**AGENDA  
CITY OF CEDAR FALLS, IOWA  
PLANNING AND ZONING COMMISSION MEETING  
WEDNESDAY, NOVEMBER 14, 2018  
5:30 PM AT CEDAR FALLS CITY HALL**

**TO:** Planning & Zoning Commission  
**FROM:** David Sturch, Planner III  
Jon Resler, City Engineer  
**DATE:** November 7, 2018  
**SUBJECT:** Park Ridge Estates Preliminary Plat

# PRELIMINARY PLAT PARK RIDGE ESTATES SUBDIVISION CEDAR FALLS, IOWA

PROJECT NO.  
5694  
SHEET NO.  
1 OF 3

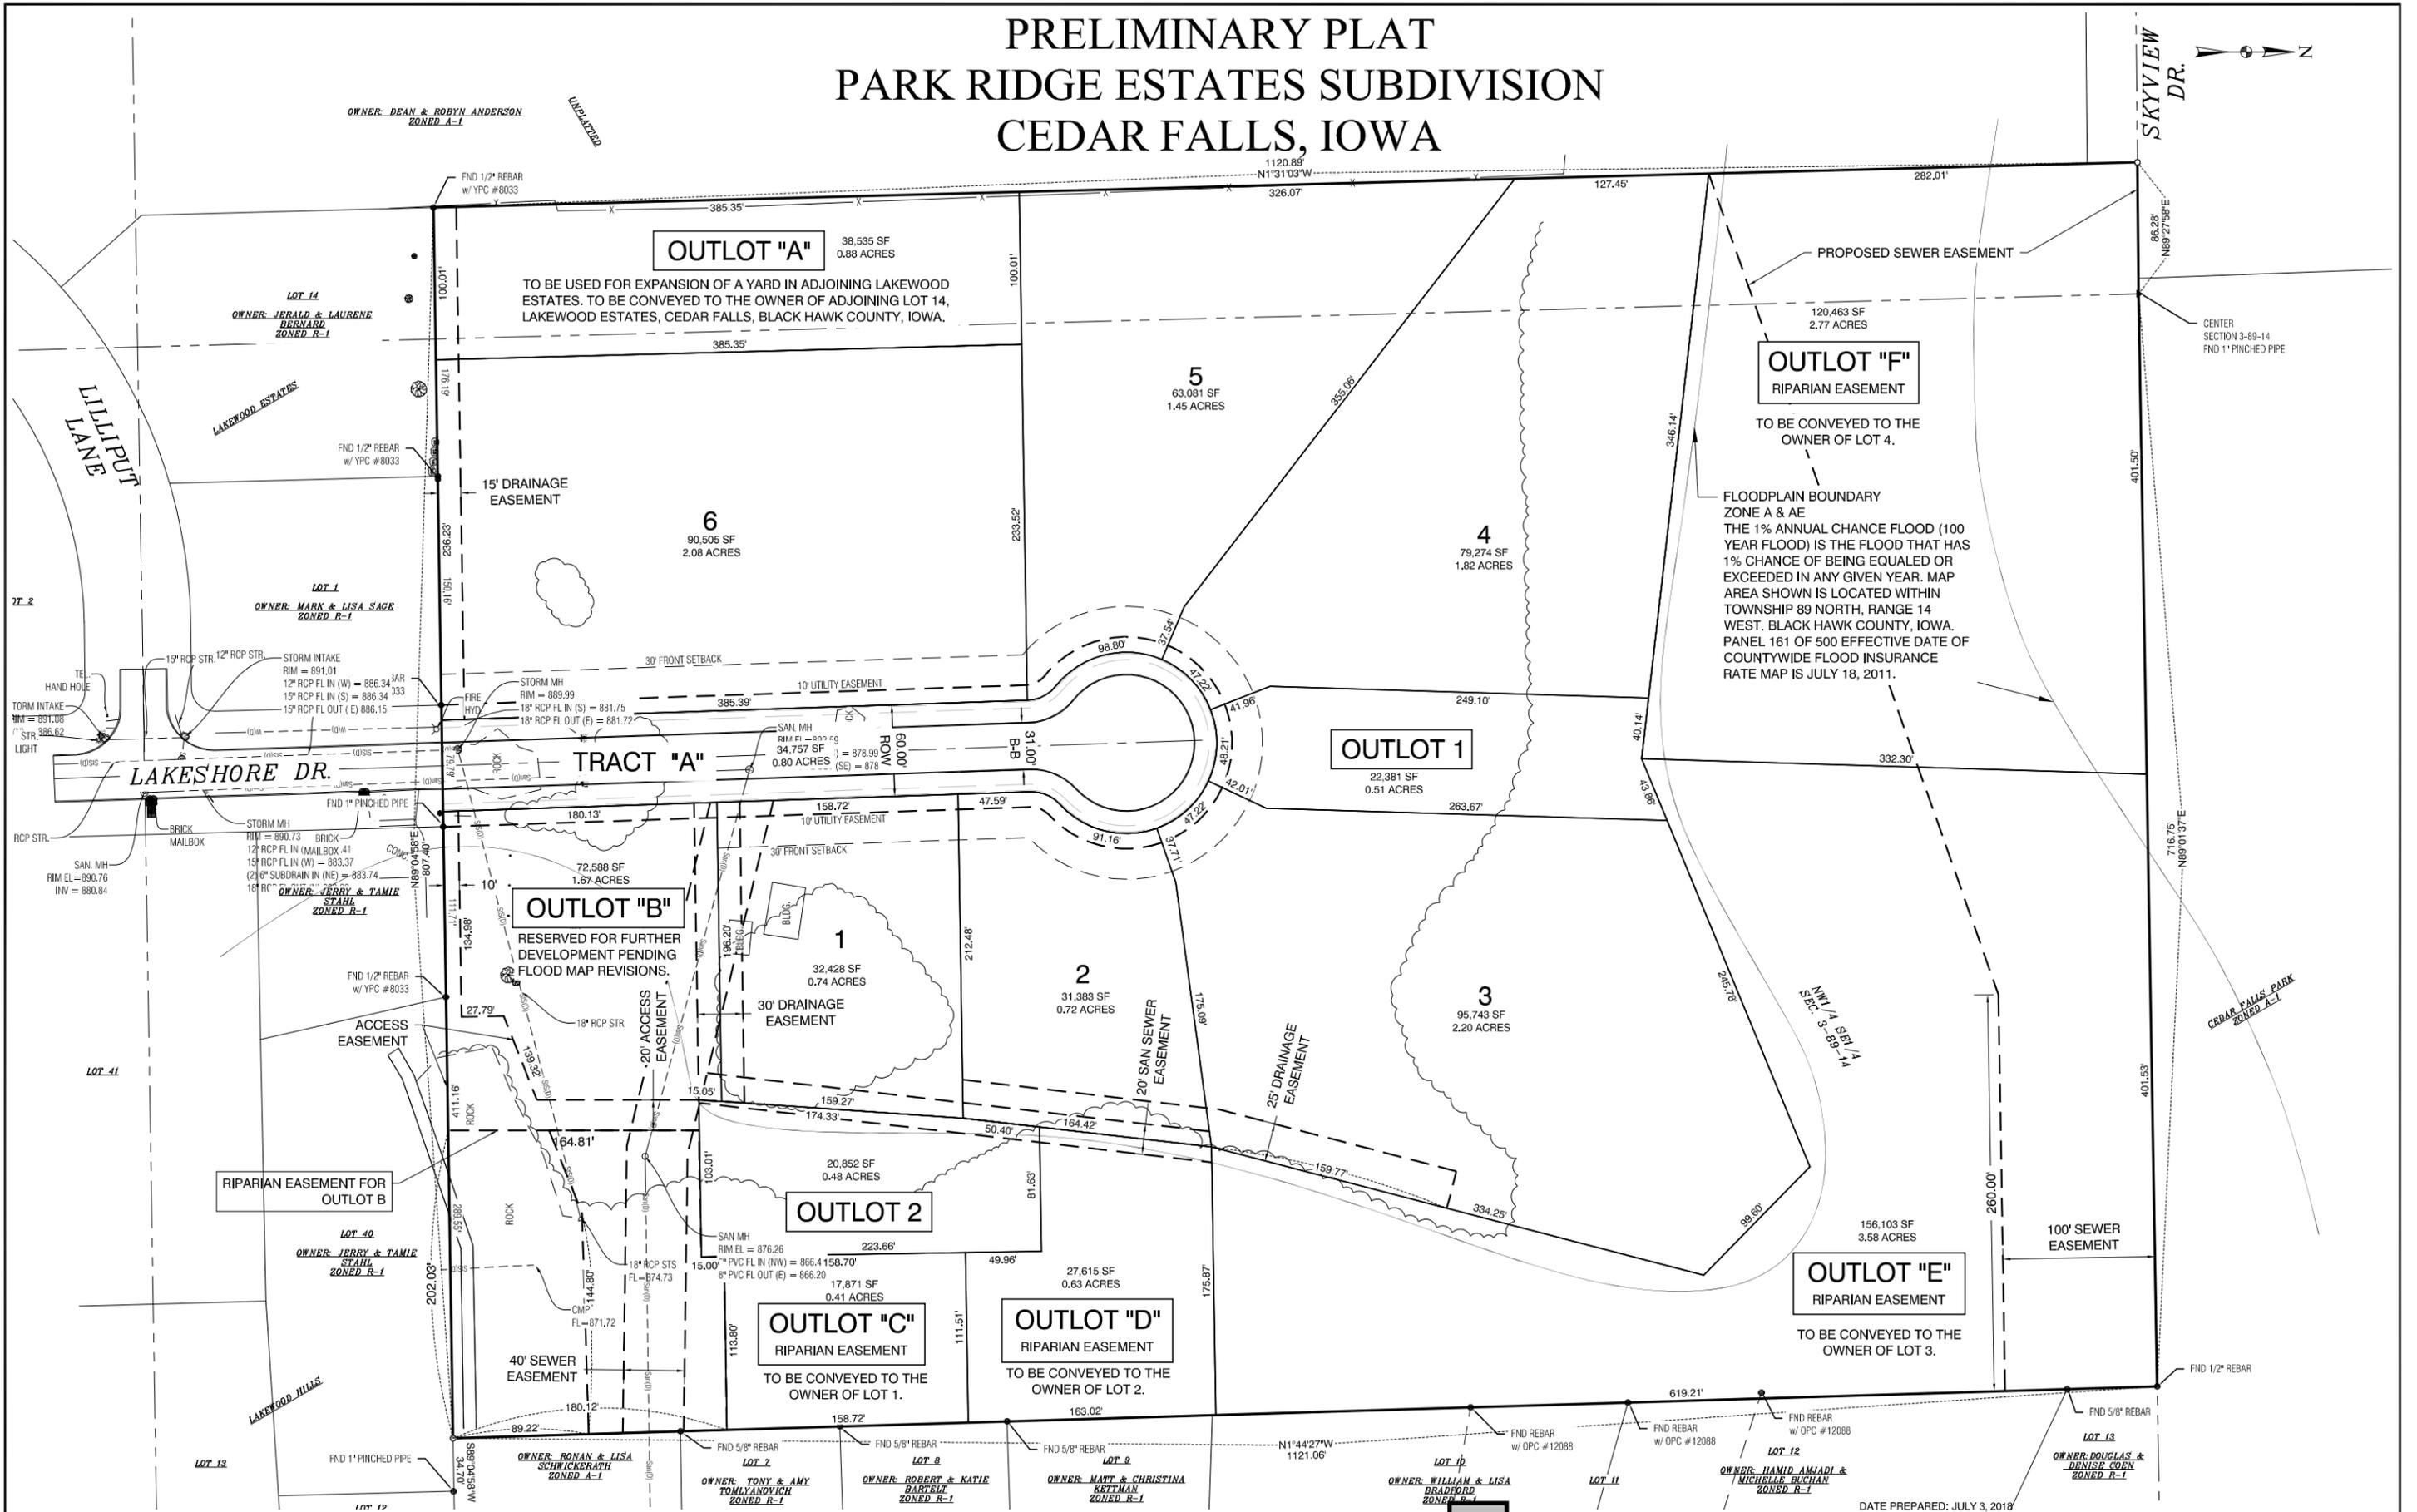
### **City of Cedar Falls Comment #1: Pipe and Intake Size and How They Will Handle Storm Run-Off**

### **City of Cedar Falls Comment #2: Overland Flow Routes and Characteristics**

### **City of Cedar Falls Comment #3: Moving the Street Ponding to the North**

Comment #1 Response: The proposed storm sewer system that leads to the east detention pond will consist of an 18" RCP (connecting to the existing 18" RCP) along with two 24" RCP's that lead directly to the east detention pond. Two intakes will be placed at a designed sump location to carry the storm run-off to the east detention pond and they will be SW-509 (8' open throat intakes) that can handle roughly 1/3 of the runoff in the 100-Year Rain Event. An overflow swale will be implemented to carry 1/3 of the runoff in the 100-Year Rain Event directly to the east detention pond. The last 1/3 of the water heading to the designed sump location will overflow (in the street) to the north detention pond. On the north side of the project, in the cul-de-sac, the design implements another SW-509 with a 24" RCP releasing directly into the north detention pond. The SW-509 will capture roughly 3/4 of the run-off in the 100-Year Rain Event with 1/4 of the runoff overflowing directly into the detention pond.

Comment #2 Response: The overflow channel heading to the east will consist of a total length from top to top of 30'. The swale will be 3' deep at typical sections will 3:1 side slopes and a bottom width of 10'. In the 100-Year Rain Event, the swale will be carrying roughly 0.5' at 5 ft/s. The design will encompass rock check dams to slow the water down and limit the erosion that the storm run-off will generate.

Comment #3 Response: The current design is to divert roughly 1/3 of the total runoff from the east detention pond to the north detention pond. This is accomplished by lowering the centerline elevation of the high point in the road to allow for less ponding in the designed sump location for the east detention pond. The information regarding the characteristics of the north ponding location can be seen in the response to Comment #1.

The erosion on Outlot B. This rut grew 8' by 8' by 10' this past week

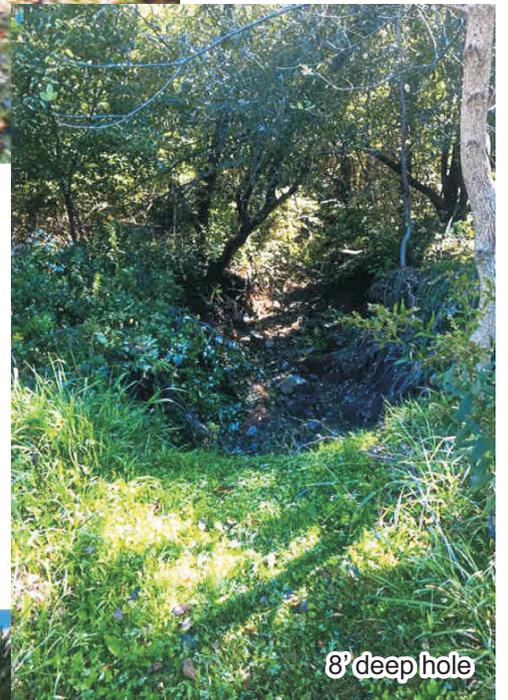
8' deep hole
